□
PRODUCT CHANGE NOTICE
PCN Form (D4-E000-73)

PCN#10-012

VLM limiter series using FF case style
VLM-33-S+, VLM-52-S+, VLM-63-S+, and VLM-72-S+

Outline Drawing

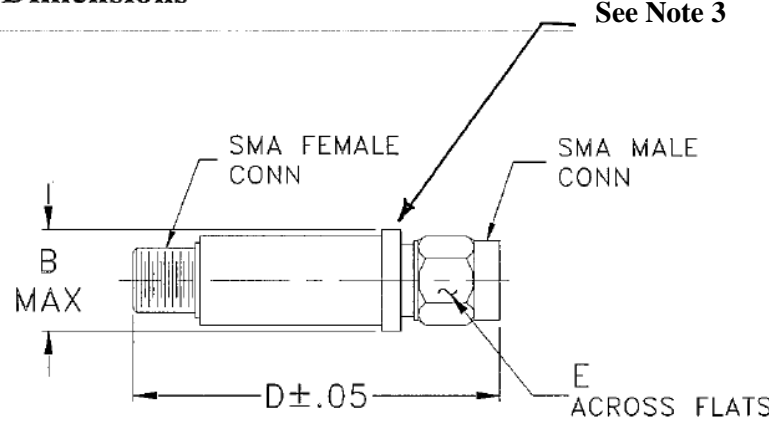
Modification of Unibody to include 'flats' to assist in SMA connector nut torquing

- Change of outline per attached drawing. No change in performance

- Changes made to enhance customer ability to torque the SMA connector nut by providing a flat surface for wrench.
